**John F. Kennedy High School**  
**A. Mandatory Referral, MR2020010**

**Description**

Mandatory Referral for the construction of a new three-story, addition to John F. Kennedy High School, which will include eight standard classrooms, one drama classroom, a special education suite, two science labs, a technology suite, a multipurpose lab, a medical careers academy, a school store, and offices. The 17,000-square foot facility will allow for an additional 429 students for an enrollment capacity of up to 2,221 students.

Figure 2: Site Plan

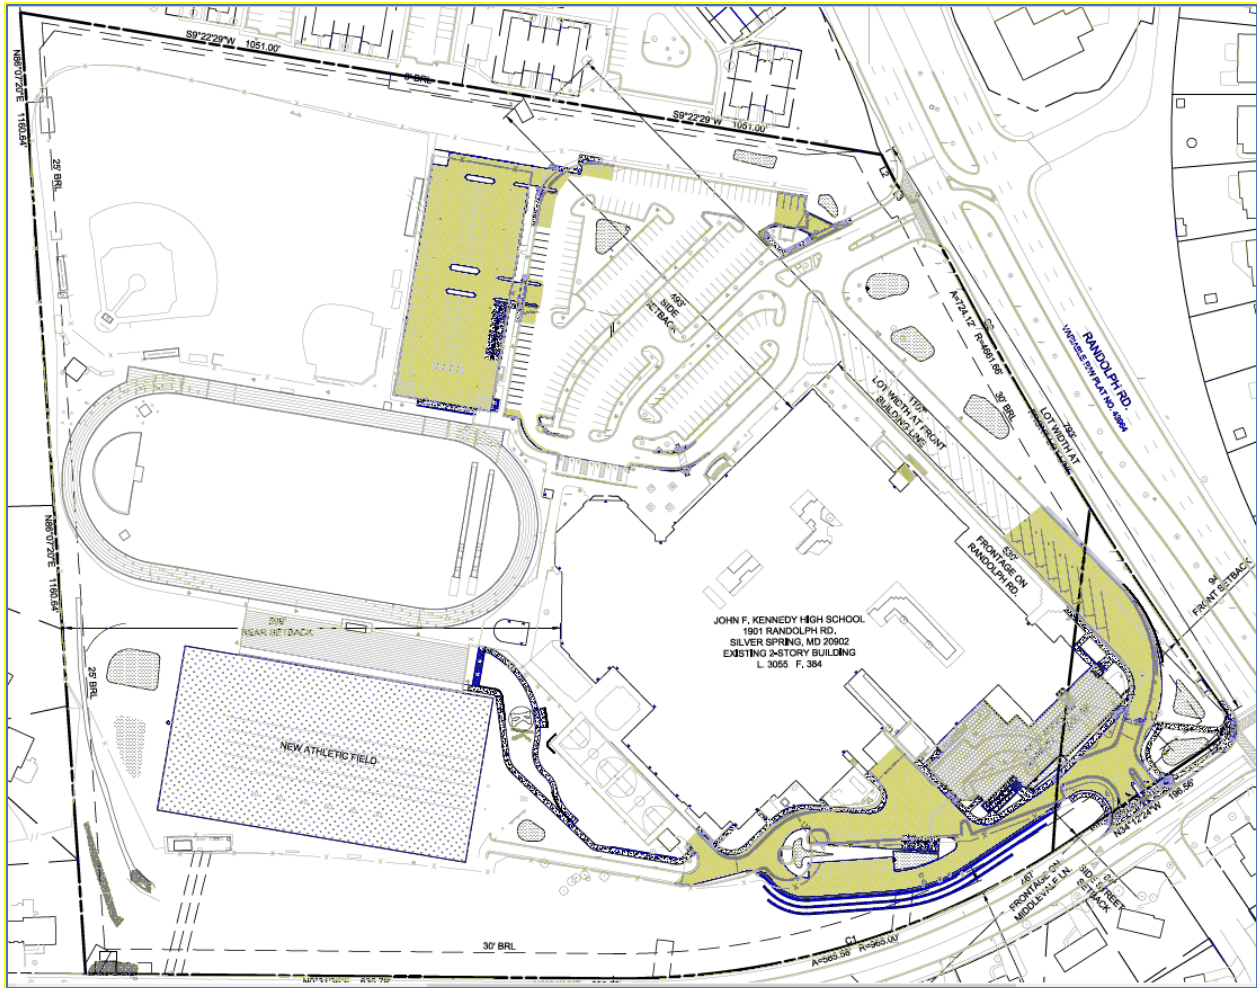
The vehicular circulation pattern is not significantly altered with the proposed expansion. Buses will continue to access the school from Randolph Road and exit on Middlevale Lane. The access point from Middlevale Lane is proposed to be widened, although the number of turn lanes does not increase. A new internal vehicular access point is also proposed to the north side parking lot. New internal sidewalks and crosswalks will improve pedestrian circulation on the Property.

Figure 3: Proposed southeast façade for the John F. Kennedy High School

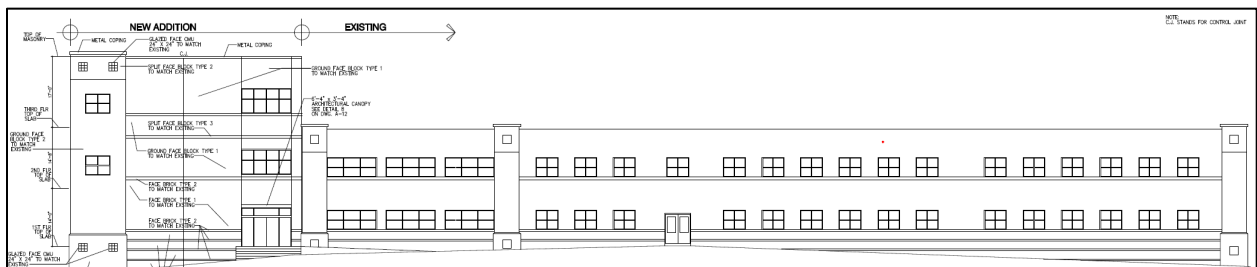
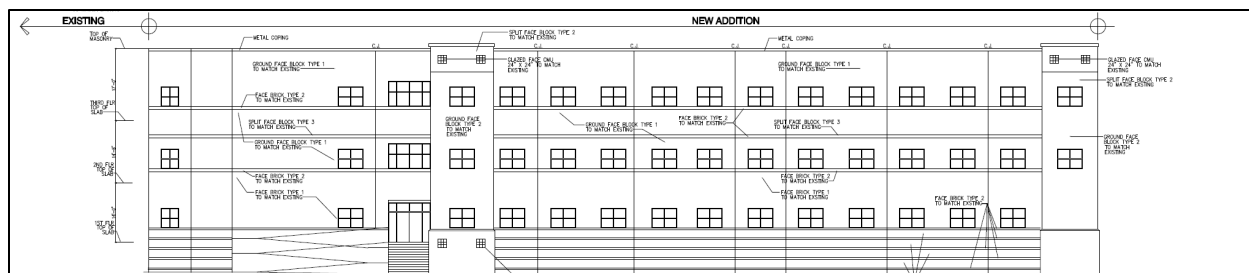
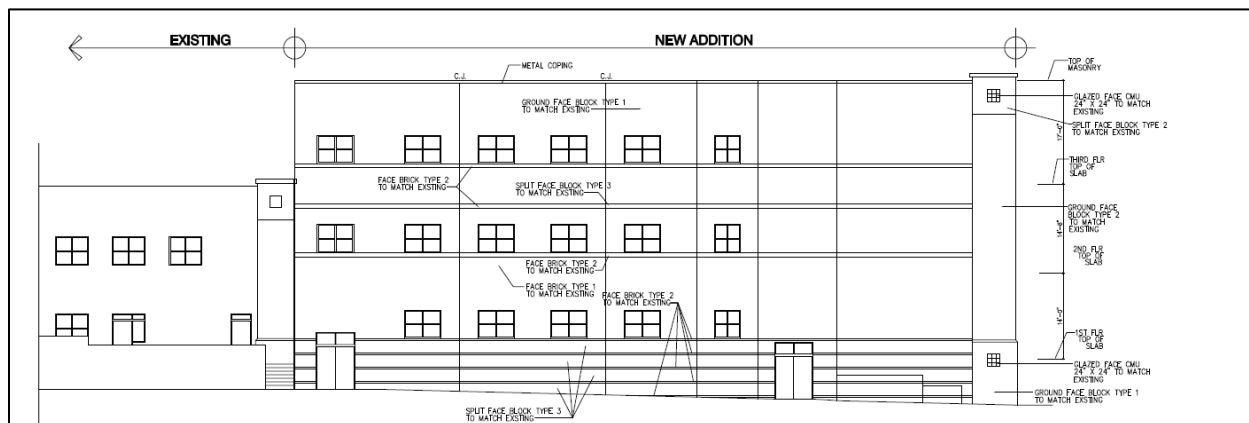
The proposed building, which will be three levels along Middlevale Lane, is steel framed with a masonry façade. The proposed addition does not make clear delineations between the base, middle and top of the building, adjusting window orientation and adding a cornice could help break up the mass of the building.
